Changes to Clause 95 discussed in the MMF Ad Hoc

September 2014

Jonathan King

Figure 95-5—Stressed receiver conformance test block diagram

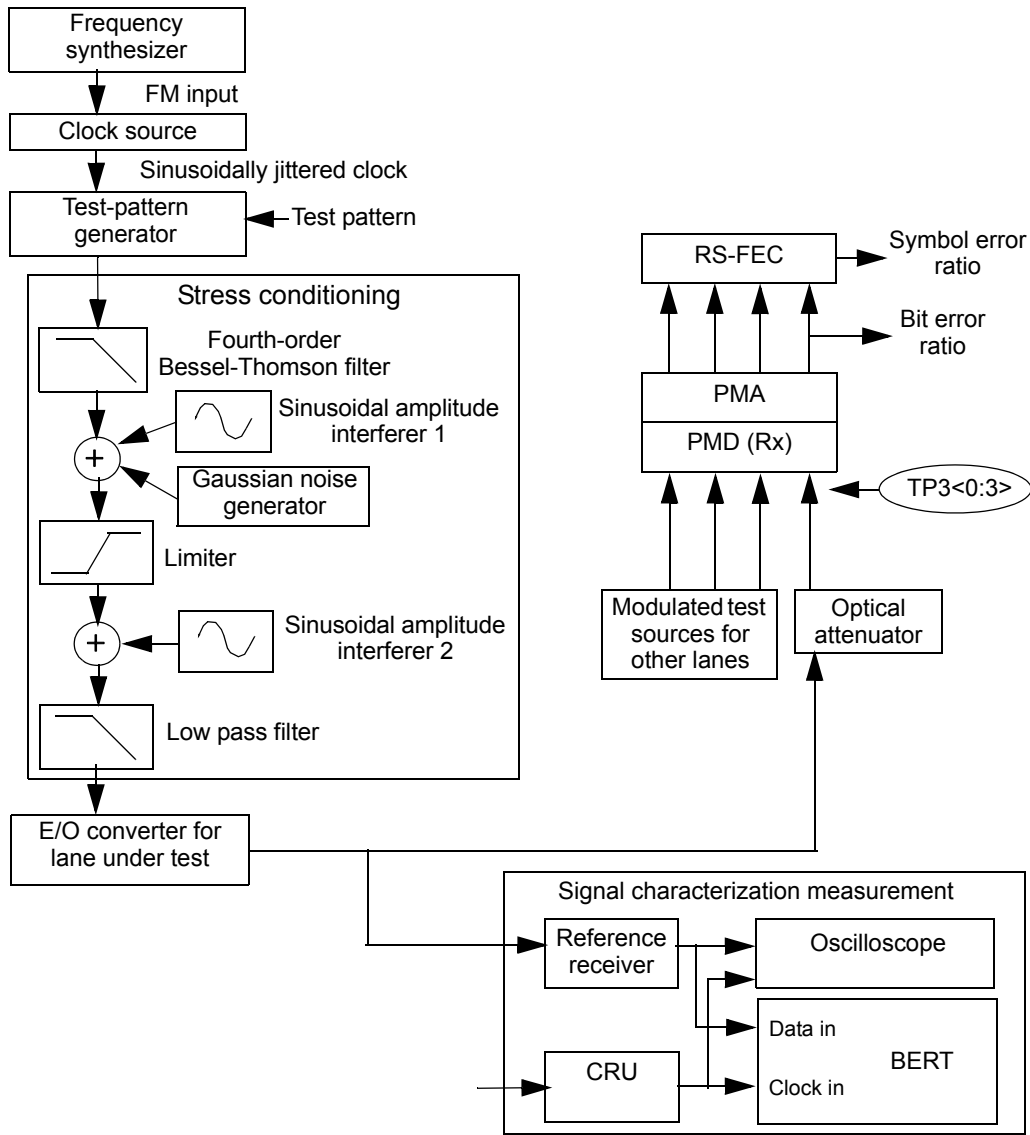
With ~~the sinusoidal amplitude interferer 1~~, sinusoidal ~~interferers~~ [amplitude interferer 2](#), sinusoidal jitter, and ~~the~~ Gaussian noise generator turned off, greater than two thirds of the dB value of the

~~VECP-TxVEC~~ should be created by the selection of the appropriate bandwidth for the low-pass filter. Any remaining ~~VECP-TxVEC~~ must be created with a combination of sinusoidal ~~interferer 2~~ or jitter, sinusoidal ~~jitter~~interference, and Gaussian noise.
